CAB,ASSY,TBL SENS-TD TS-A
ASSEMBLY DRAWING

PART NO.	REV	DOC	SHEET	OF
10 - 3679B - A	AD		1	1

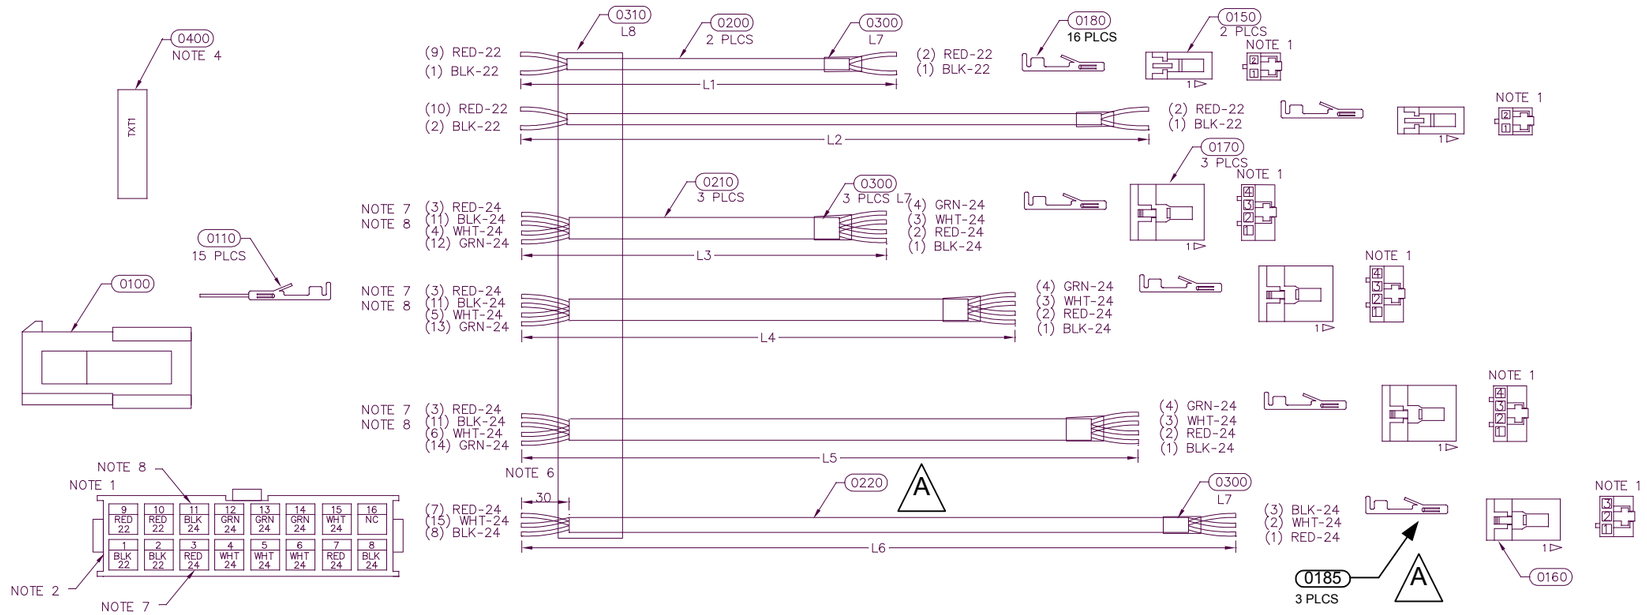
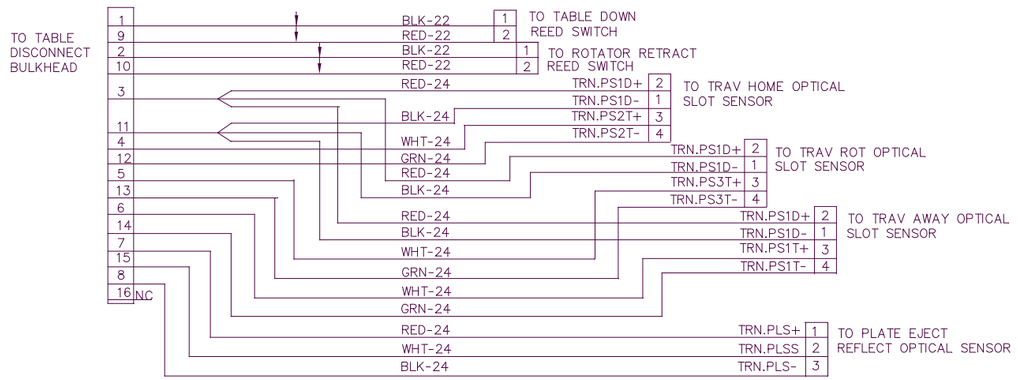
A This Version only changes the pins on the plate eject sensor end of the cable from gold to tin plating.
and changes the length of L6 to 1850 mm
